SR 525

MUKILTEO FERRY TERMINAL (PHASE 2) FERRY TERMINAL CONSTRUCTION

VOLUME 5 OF 8

VOLUME 5 SHEET INDEX

RFI 235 - Men Restroom 205 Floor Cleanouts

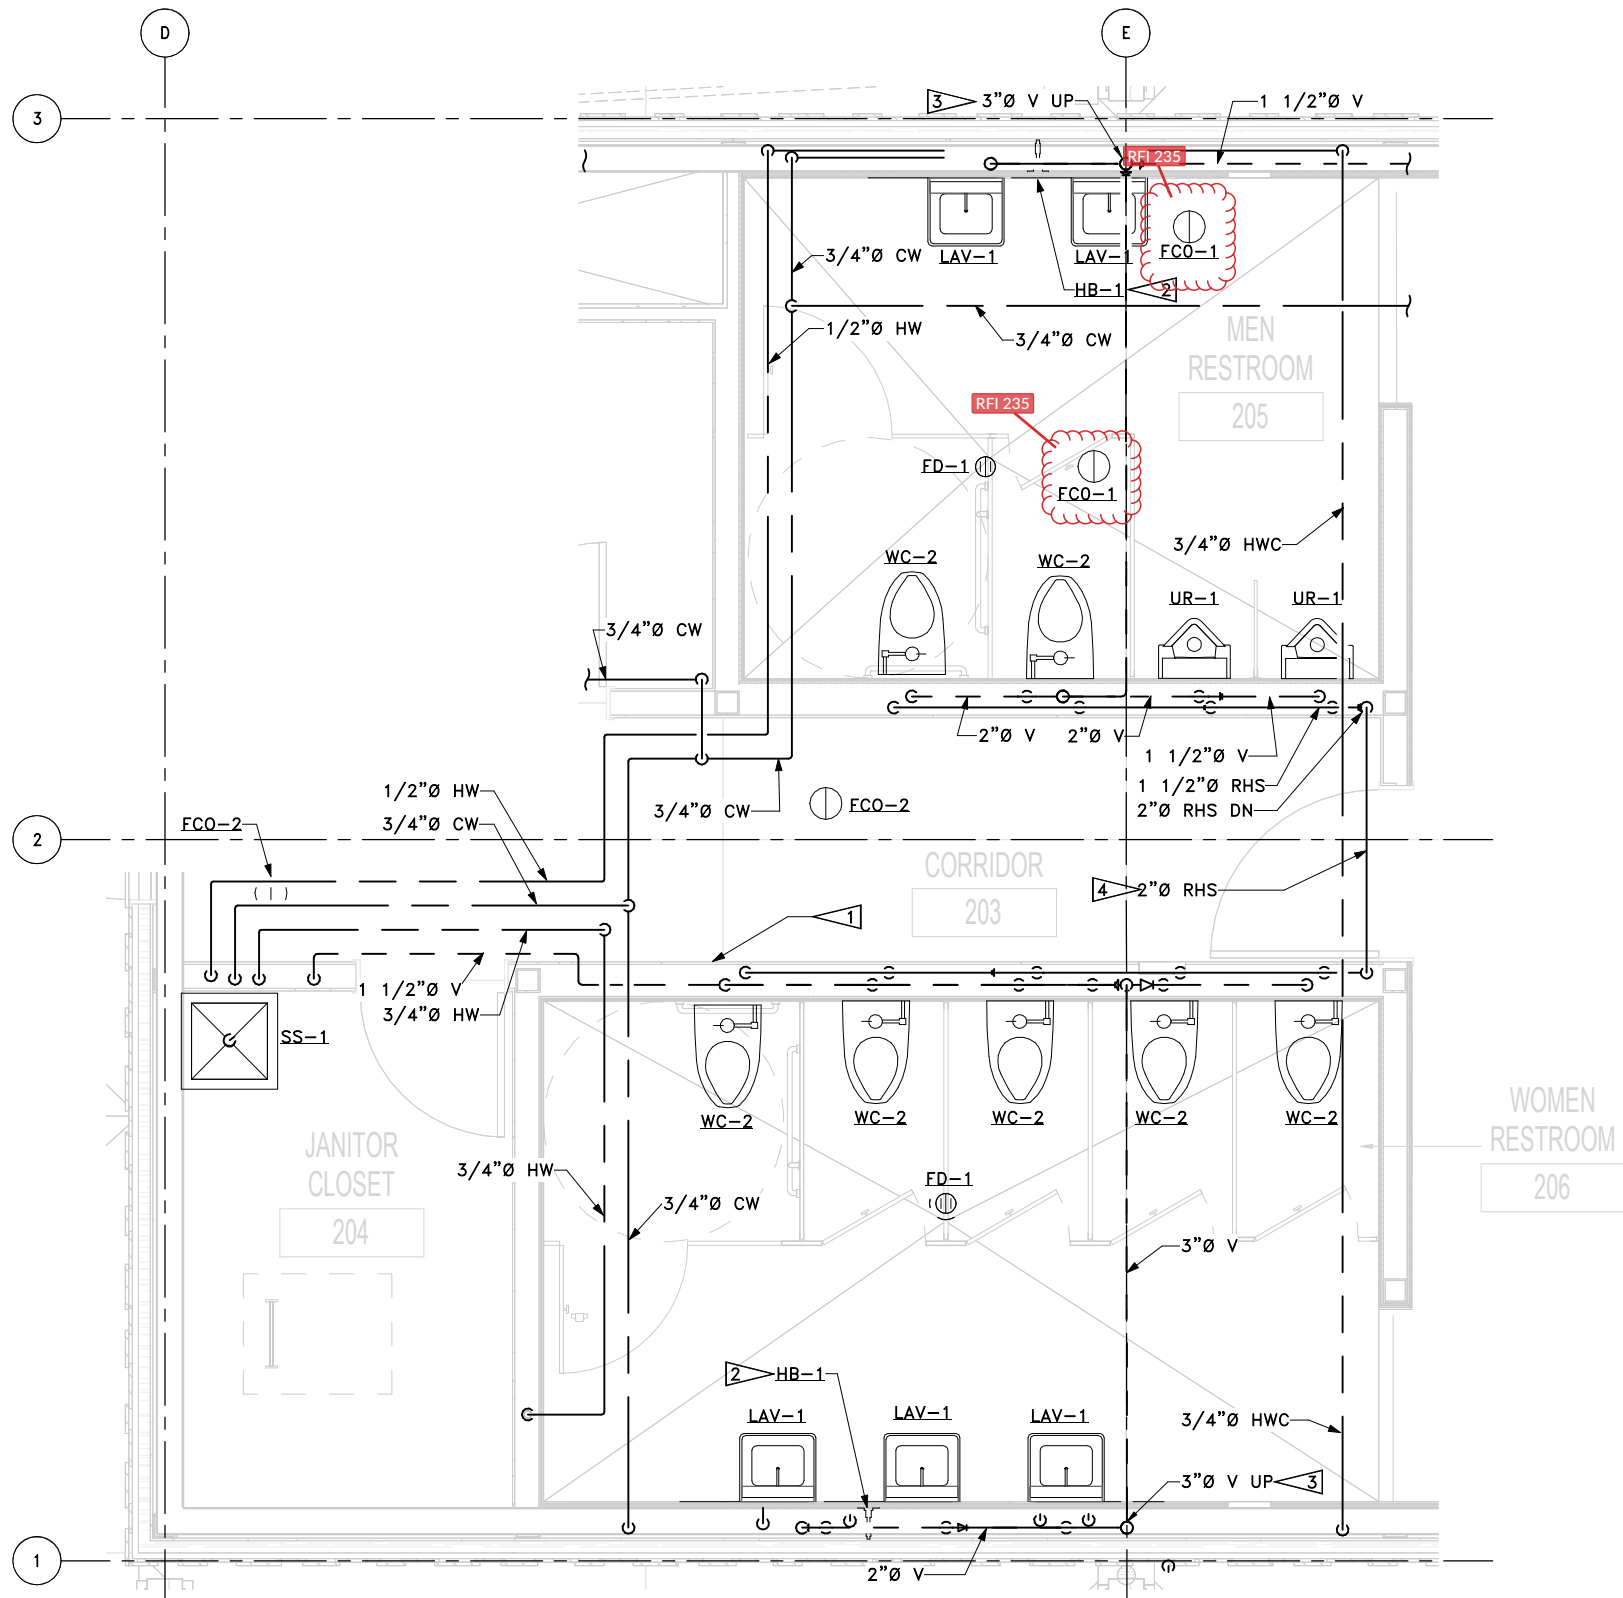
Confirmed that floor cleanouts in question (clouded and highlighted in yellow on attached pages) can be eliminated. As a general reminder, not all cleanouts are shown on plan. Per specification 221000, we expect cleanouts to be installed in locations dictated by the Uniform Plumbing Code (at the end of chase-ganged fixtures, under urinals, at direction changes exceeding 135°, etc.).

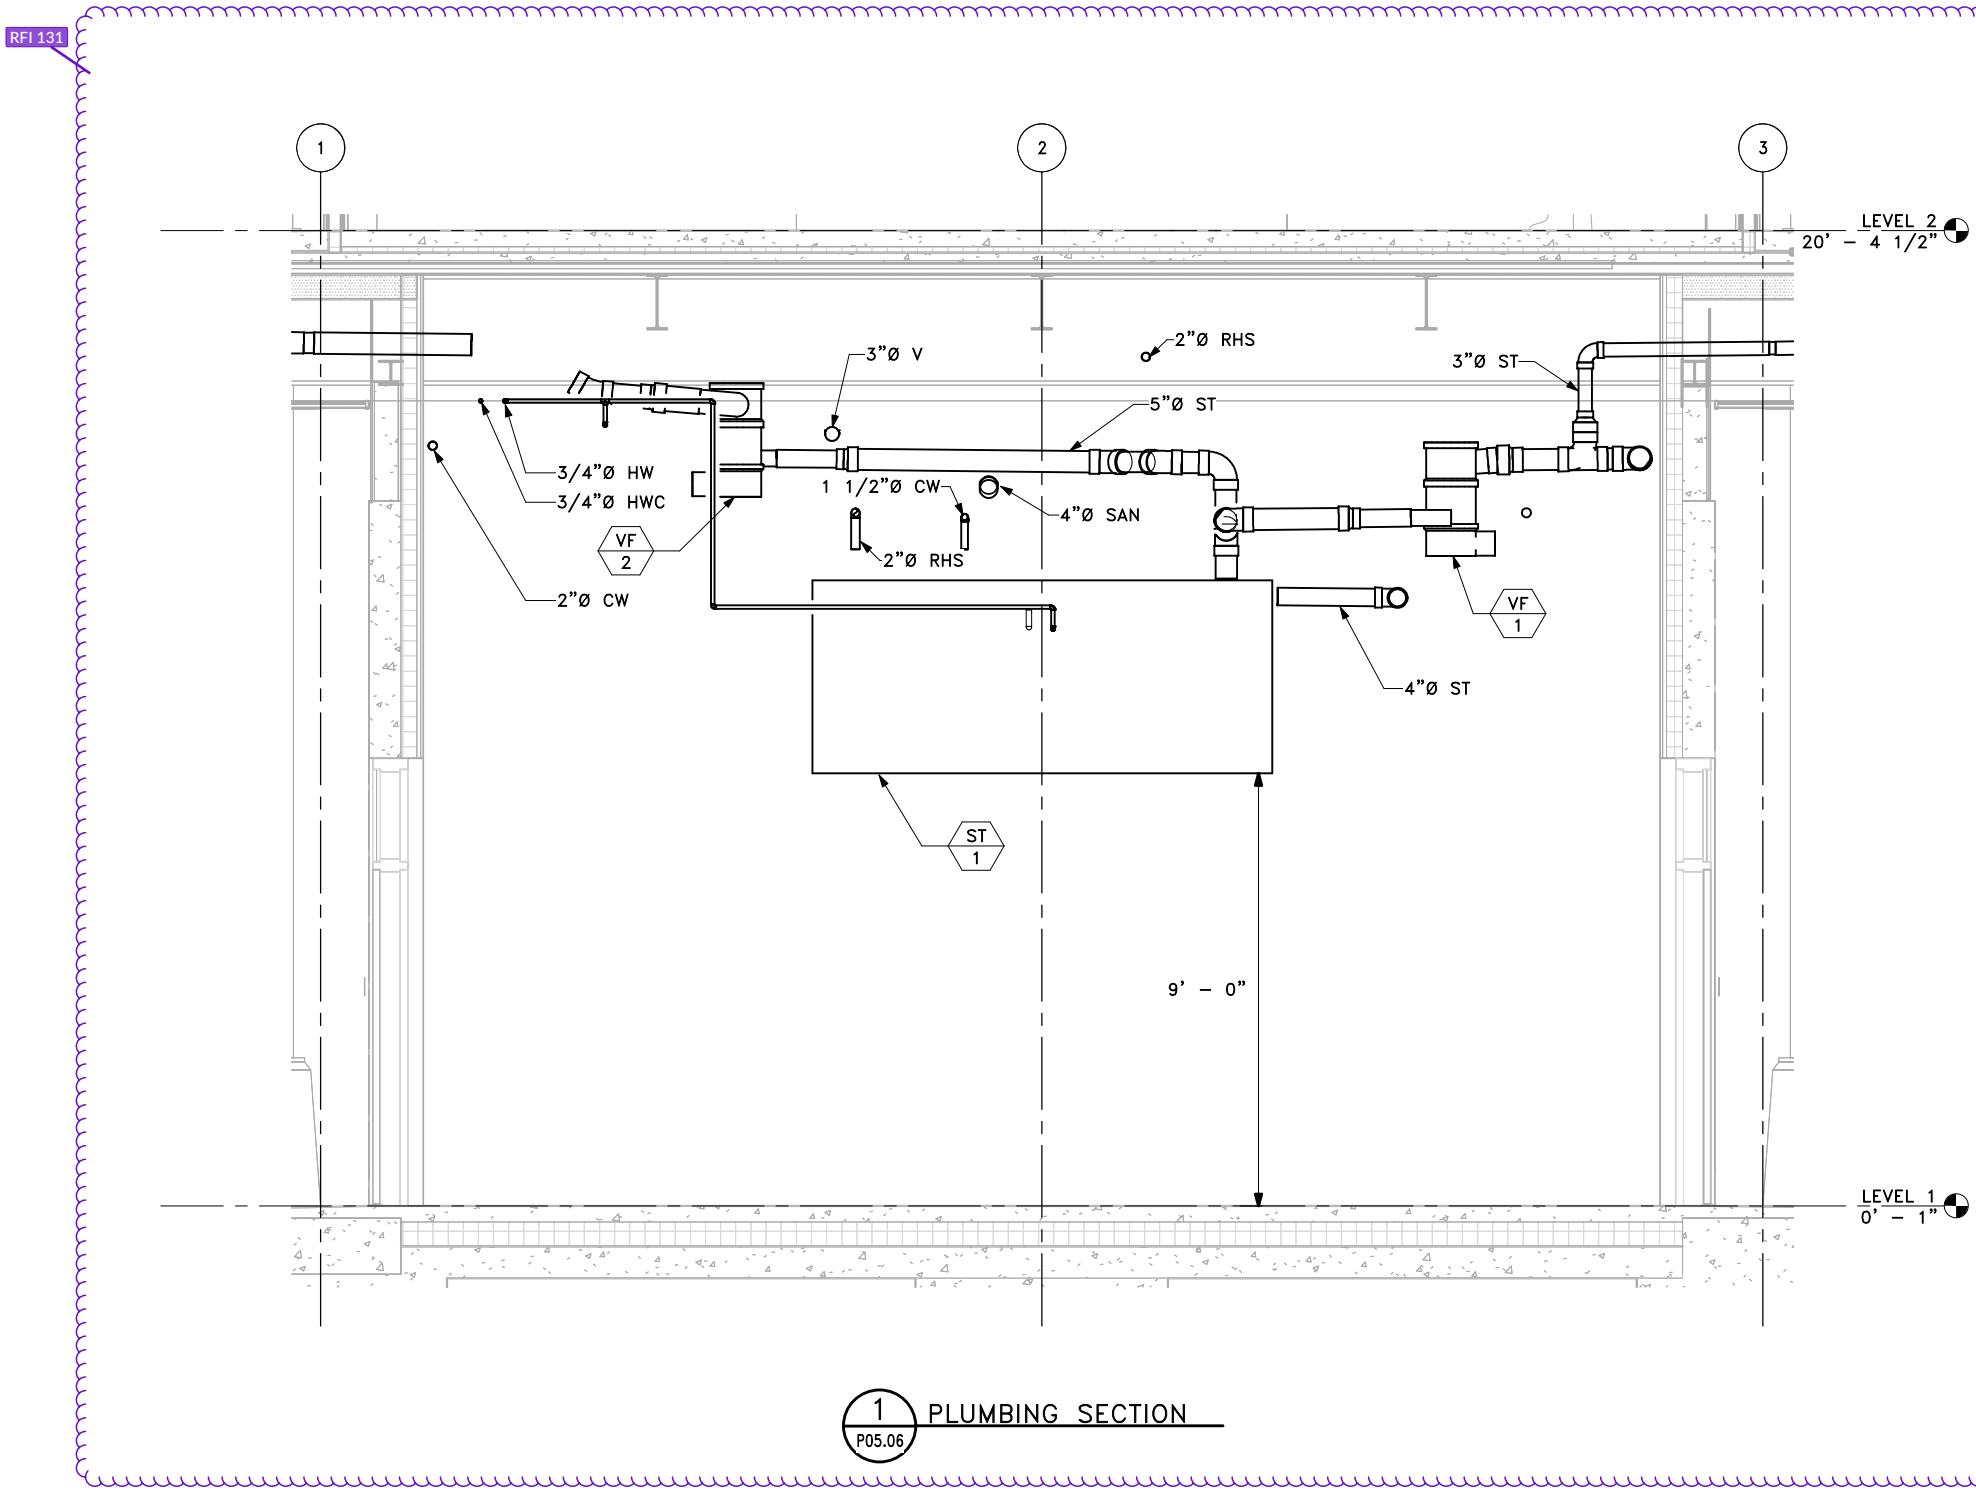
1. Contract documents are diagrammatic. Contractor to determine final configuration. Per cut sheet provided, filter can be installed above ground using custom stand or bracket. Contractor to review and provide proposed support for filter per specification section 22 05 29.

2. Contract documents are diagrammatic. Contractor to determine final configuration. Reviewing the plumbing section, relocating the filter to allow for 10' of straight pipe prior to filter seems feasible and is acceptable. 10' of piping is recommendation based on max flow. The design flow of 130 GPM flow is much lower than filter max. An RH9520-6 requires only 24" of straight pipe prior to filter. Therefore suggested straight run of pipe is to be 6' or 72". Provide eccentric reducer and 12" pipe prior to filter.
